Division of Ecological & Water Resources
Region 4 (Southern Region)
21371 Highway 15 South
New Ulm, MN 56073

April 22, 2021

Re: Final Engineer's Report (FER) for Heron Lake Watershed District – Jackson County Judicial Ditch 3

Figure 11: Outlet Hydrograph (10-Year Storm Event - Free Outfall)

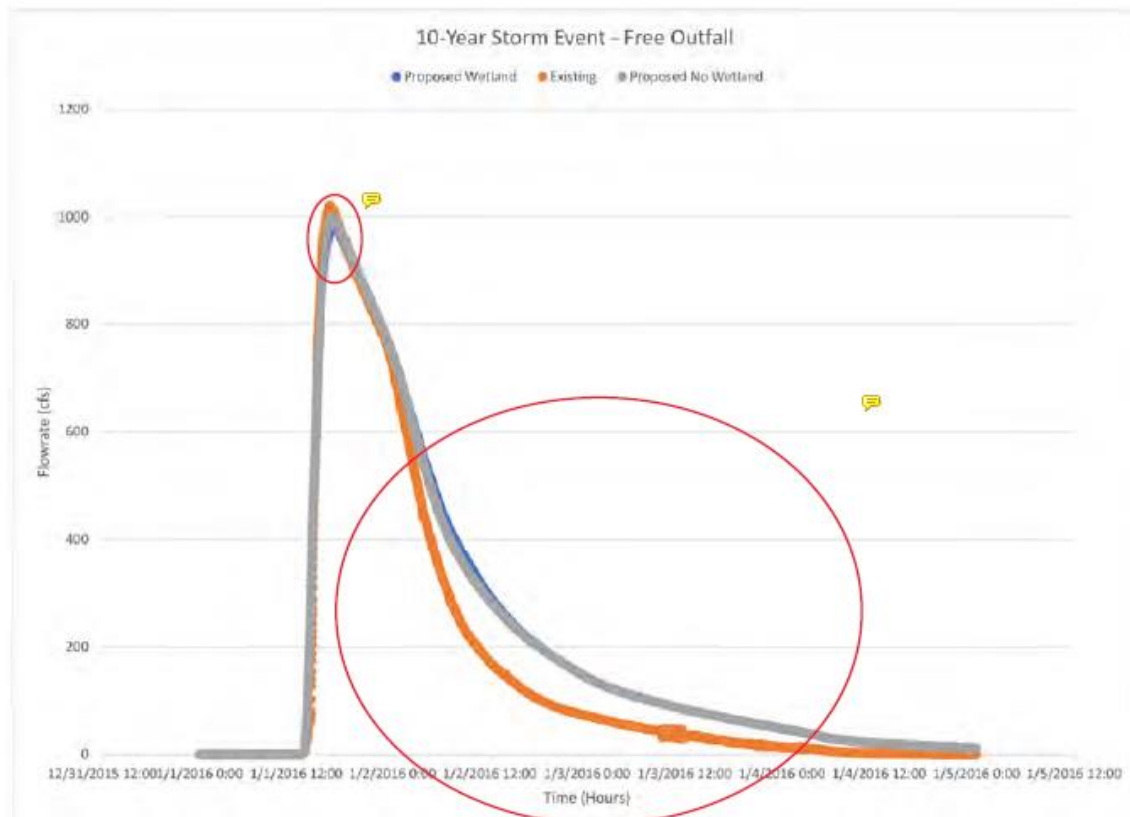
A total of 97 acre-feet of storage are proposed, 73.8 acre-feet of which is identified as necessary to ensure the outlet is adequate. We note that 97 acre-feet of storage is equivalent to 0.05” inches of runoff from the entire JD3 watershed. From a common-sense standpoint, it doesn’t seem possible for this relatively meager storage volume to influence the system in a substantial manner. Furthermore, the FER presents hydrographs which show the amount of water leaving the JD3 ditch for a 10-year storm event (one copied in below), which appear to support this.

The proposed conditions scenarios - with wetland (blue line) and without wetland (grey line) - are extremely similar. By implementing the proposed storage, the hydrograph shows a minor decrease in peak flow of the proposed system (refer to the small circle at the peak of the graph). However, the hydrographs clearly show a significant increase in the total storm event volume (refer to the large circle on the falling limb of the graph).

The total volume of storm events may be more likely to affect the adequacy of this outlet than the peak flow rate because the JD3 outlet is controlled by the South Heron Lake outlet. We ask that the original justification of the inadequate outlet be discussed as well as specifically describe how adding the storage areas allow the outlet to be adequate, even though it makes almost no change to the peak of the hydrograph. We also request additional modeling information be included in a modeling report. The modeling request is incorporated in the Modeling Request Section below.
